## DISABILITY AND COMMUNICATION ACCESS BOARD

### INTERPRETIVE OPINION

Docket: **DCAB 2018-04: If the change in level at a doorway without a door (cased opening) is greater than the maximum threshold height allowed, can a ramp be used?**

**EXAMPLE: SECTION AT CASSED OPENING**

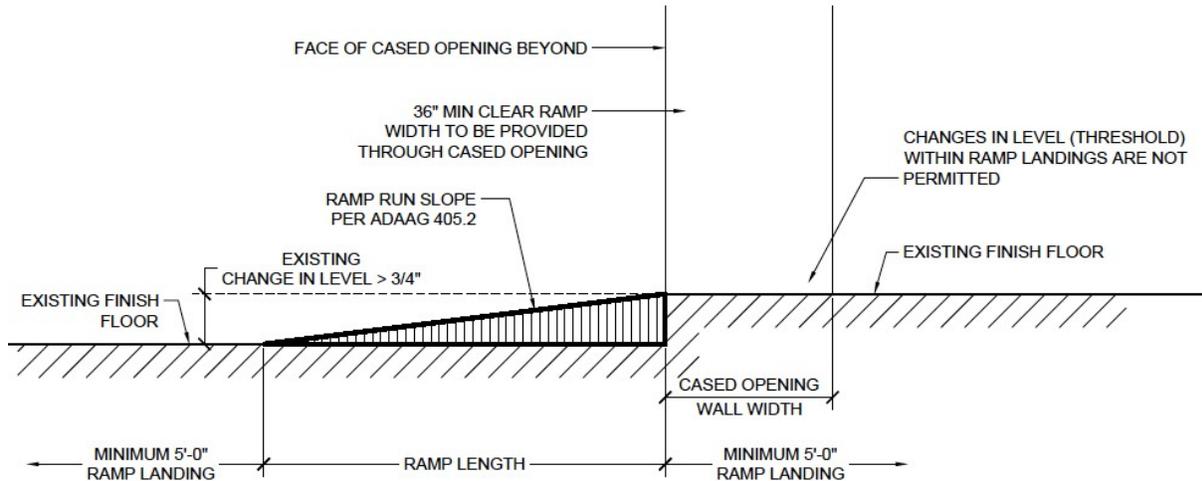
Summary: Per ADAAG 404.2.5, the maximum door threshold height is ½ inch, ¾ inch for existing or altered thresholds. Since a door threshold is considered a change in level, it is also required to comply with the requirements of ADAAG 302 and 303. ADAAG 303.4 states that changes in level greater than ½ inch are to be ramped and comply with ADAAG 405.

A ramp may be used at a cased opening, provided the requirements of ADAAG 404 and 405 can be met.

Where a change in level occurs at a doorway without a door (cased opening), and the change in level exceeds the maximum threshold height allowed by ADAAG 404.2.5, a ramp may be used to navigate the change in level provided the cased opening and ramp complies with the applicable requirements in ADAAG 404 and 405, including but not limited to: slopes, landings, changes in level and clear widths.
